TENDER DRAWING

KUMAR TALPADE CHARTERED ARCHITECT DNT DESIGN SERVICES LTD 86 ALBURY DRIVE PINNER, HA5 3RF	REVISIONS NO. DATE A REDRAFTED PLANS 8/02/20 B REVISED AS SUGGESTED BY THE CLIENT 12/02/20 C REVISED USE OF KIT 4 14/07/20 D WINDOW TO STUDY - HT REVISED 8/8/20	OWNERS: MR. VIVEK SHARMA PLANS AS PROPOSED	3 MEZEN CLOSE NORTHWOOD, HA6 2DP RENEWAL OF PLANNING APPROVAL WITH MODIFICATION SCALE: 1:100 (A3) DT: 8/02/20 DRG NO: DNT/3 MEZ./P/10 B
---	---	---	--

GROUND FLOOR PLAN PROPOSED

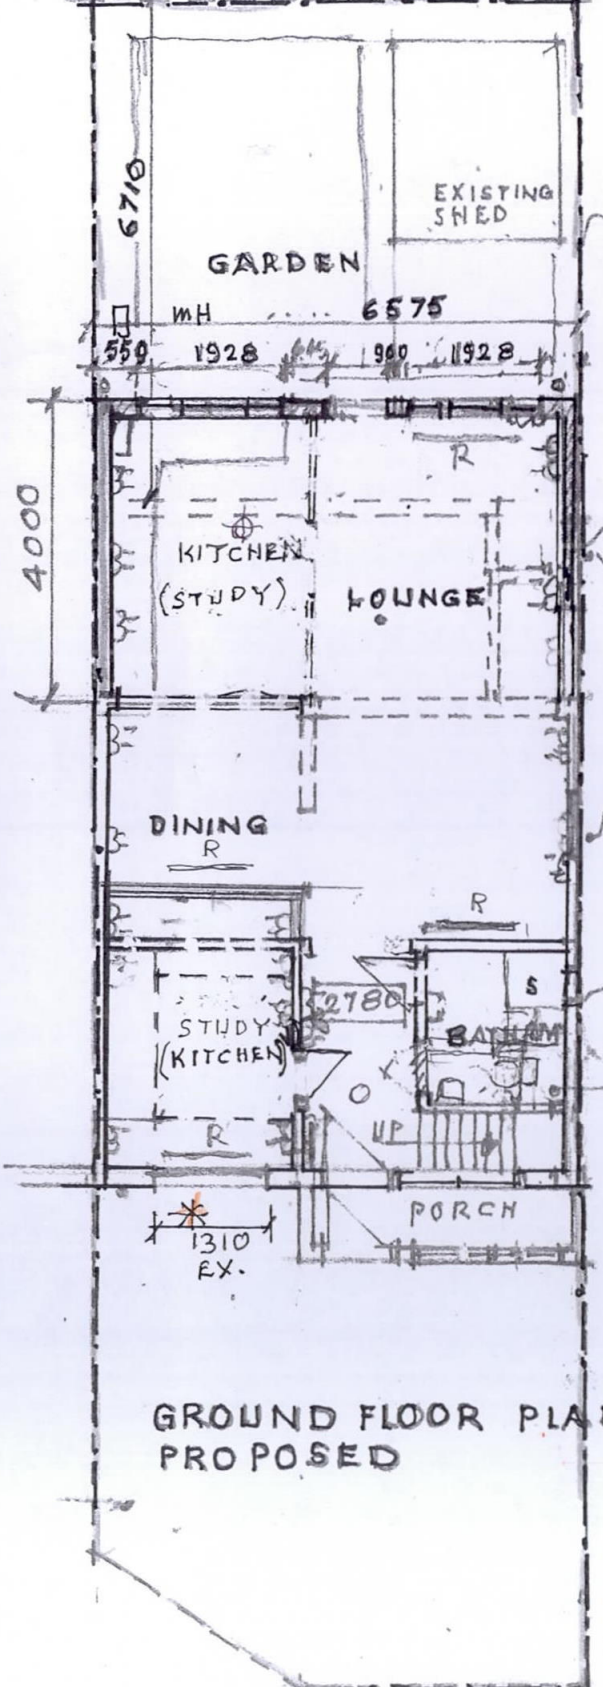
* NOTE: THE PLANNING APPROVAL UNDER REF NO 73094/APP/2020/700 DATED 27/04/20, CHANGES MADE AS FOLLOWS:
 * KITCHEN IN FRONT WILL BE USED AS STUDY
 * STUDY AT REAR WILL BE USED AS KITCHEN

FRONT ELEVATION

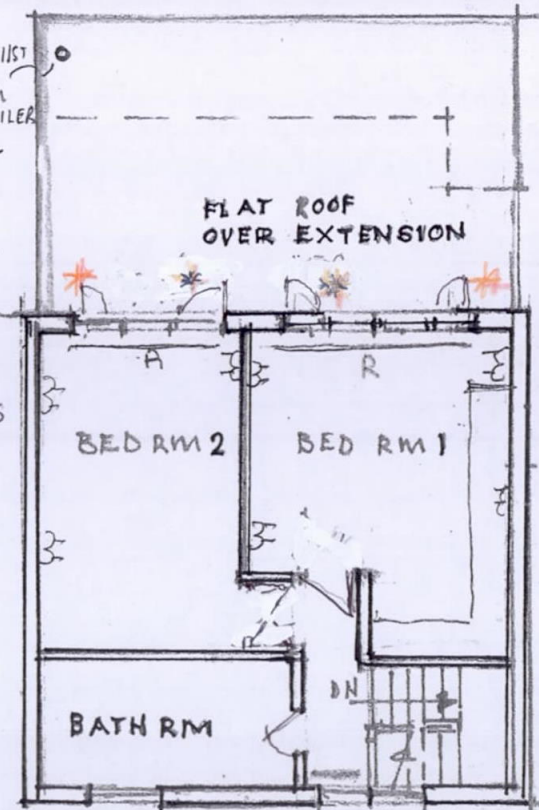
* REVISED HEIGHT OF WINDOW TO STUDY.
